## TAHOE REGIONAL PLANNING AGENCY

### MEMORANDUM

Subject: **REVISED:** Seymour, Land Capability Challenge, 15 Tahoma Ave., Placer County, CA; APN: 093-092-006, TRPA File #: LCAP2010-0362.

**TOPOGRAPHIC SURVEY**  
FOR  
**KEN SEYMOUR**  
15 TAHOMA AVE. - APN: 093-092-006  
LOT 142 - DOLLAR POINT #2 SUB DIV.  
PLACER COUNTY CALIFORNIA

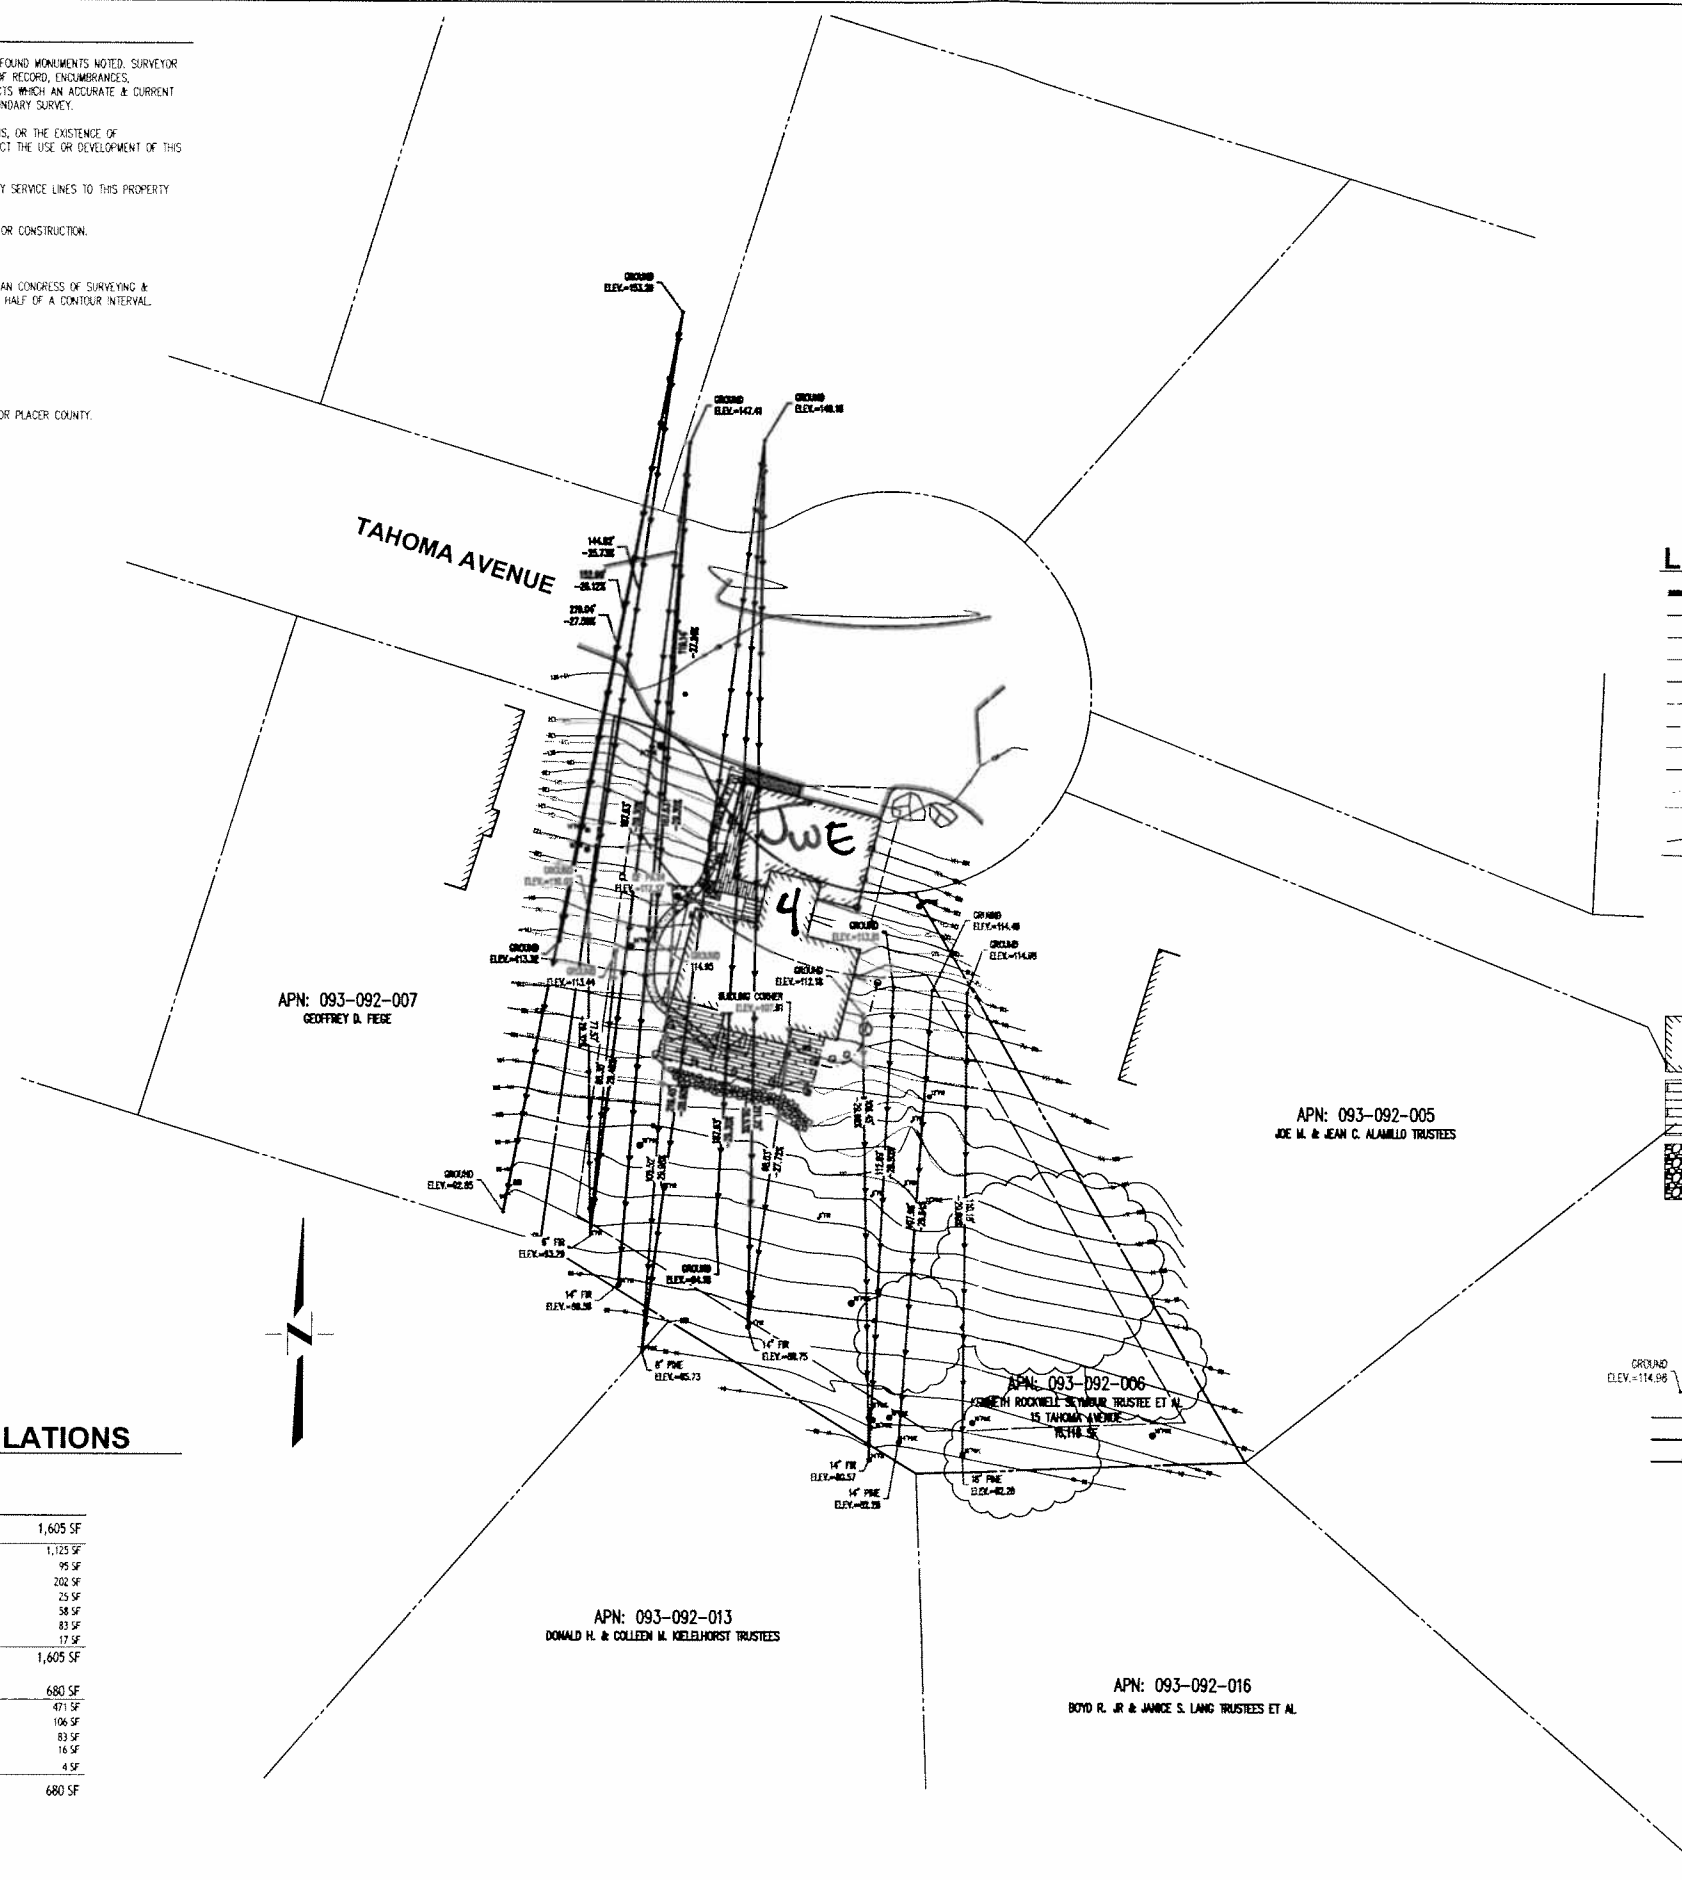
Based on the already approved Jw soil designations, areas on the subject parcel with slopes ranging from 15 to 30 percent were designated Class 4 and areas with 30 to 50 percent slopes were designated Class 2. Original slope analyses (based on the topographic survey provided with the application) indicated slopes ranging from 35 to 40 percent in the area in question, with the remanding lot having a slope phase of 27 percent or greater. This was the basis for the original JWF Class 2 recommendation.

Although determined on a case-by-case basis, TRPA has excluded cut and fill areas when conducting slope analyses to determine natural grade and land capability classes on a parcel.

Findings: Based on the site visit and review of the additional topographic survey information TRPA staff concurs with the applicant's presentation that the Class 2 area in question is over-steepened due to fill material. Natural slopes in the area in question are estimated to range from 27 to 30 percent and, therefore, appropriately re-designated Class 4.

Staff recommends that this area of JwF Class 2 be changed to JwE Class 4.
